Te Kuha Opencast Mine - Geochemistry Review

Department of
Conservation
Te Papa Atawhai

Te Kuha Opencast Mine - Geochemistry Review

994-1-1

Figure 4.1: Price (1997) minimum number of samples for preliminary acid base accounting

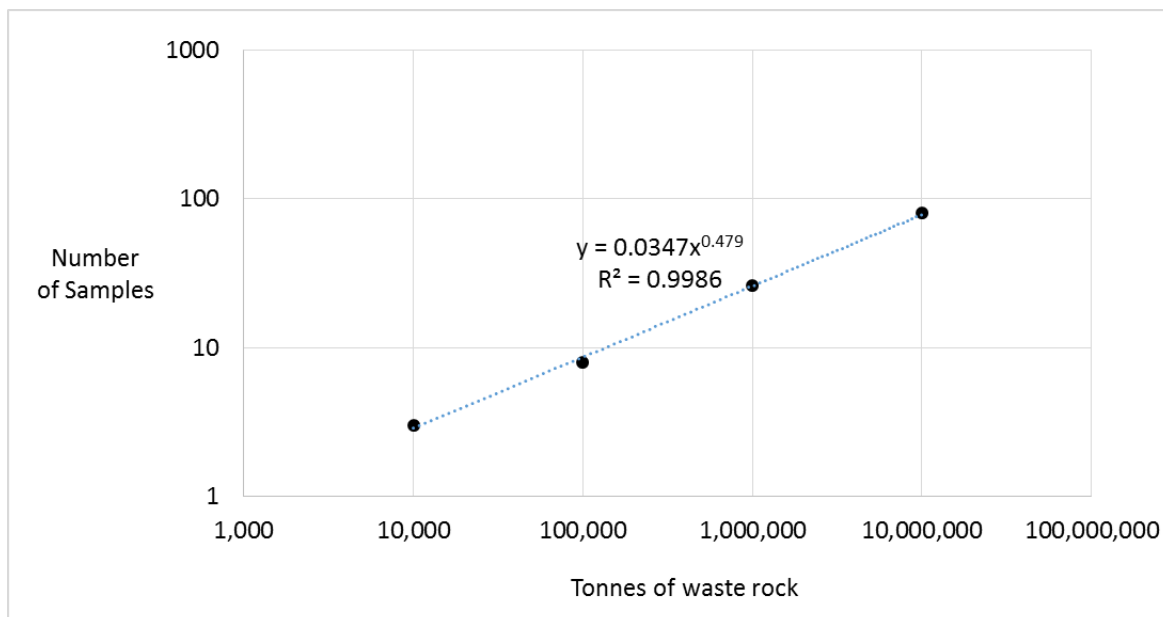
CRL Energy Limited (2014) state that 46 ABA tests have been undertaken, whereas the MEND guidelines would suggest ~100 would be more appropriate for a project of this size (~15 M tonnes).

Further ABA testing will be required as part of ongoing project development and during mine operations. However, it is reasonable to expect testing and sampling processes can be developed as part of an adaptive management plan for AMD.

Figure 5.1: Proposed infrastructure for the Te Kuha Coal Mine – Year 1

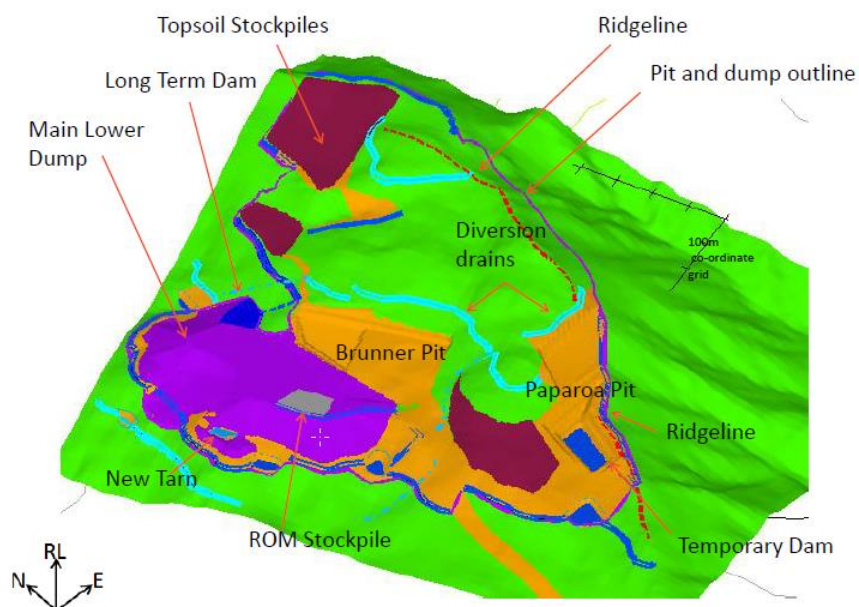
- A clear mining schedule is needed, which should be linked to the volumes of each geochemical type of waste rock that will be placed in each dump such that NAF PCM and BCM can be separated and re-handled appropriately. The development of the waste rock dump design and schedule should be linked to the preliminary waste rock block model. This should be updated as more geochemical and geological data become available through an adaptive management process. CRL Energy Limited (2015) note that a plan of the temporary waste rock dumps should be completed, which presumably relates to such matters. This needs to be reviewed.

- Explanation is required on how the Main Lower WRD will be lined with NAF PCM and for what purpose.
- Clarification is required as to the process of progressive rehabilitation followed by subsequent re-handling of this material. It seems onerous to undertake rehabilitation activities and then dig it up.

- Traffic management and QA/QC processes will need to be developed to ensure the correct placement of waste rock within the ex-pit WRDs and the backfill.

Figure 6.1: Scenario 1 Zn water quality predictions for proposed compliance points for West Creek and Camp Creek

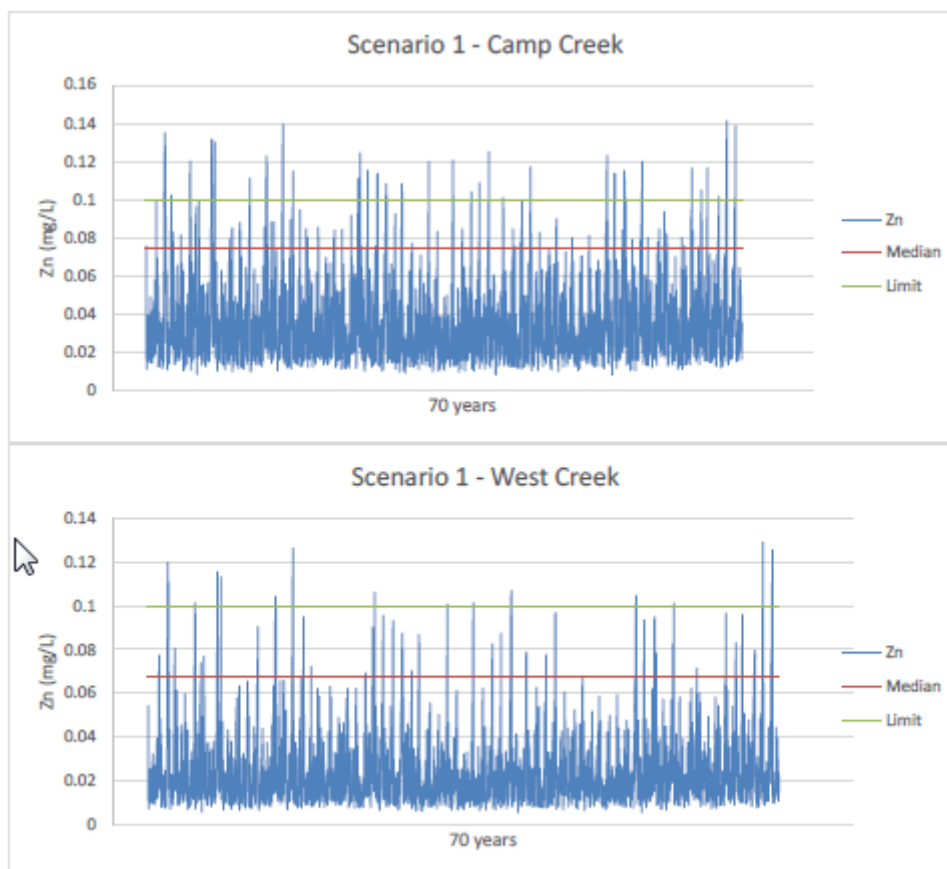
- CRL indicates that Fe concentrations are likely to be low in site leachate waters based on data from the field column leach tests. However, the field column leach tests were conducted under oxidising conditions. It is proposed that the waste rock dumps at Te Kuha will be built in ~5m lifts to minimise grainsize segregation and chimney effects which will minimise oxygen ingress and thus parts of the WRD will be low in oxygen and Fe²⁺ could thus remain in solution. Consideration of this is required for operational and longer-term water management.

- CRL Energy Limited (2016) indicate that Ni, Zn, and Mn remain dissolved and are likely to remain dissolved through neutralisation to pH~7. Such matters require consideration for both operation management and management after closure in the longer term. Modelled Zn concentrations based on Scenario 1 are presented below in Figure 6.1 and are greater than potential discharge limit of 0.1 mg/L Zn (CRL Energy Limited, 2016).
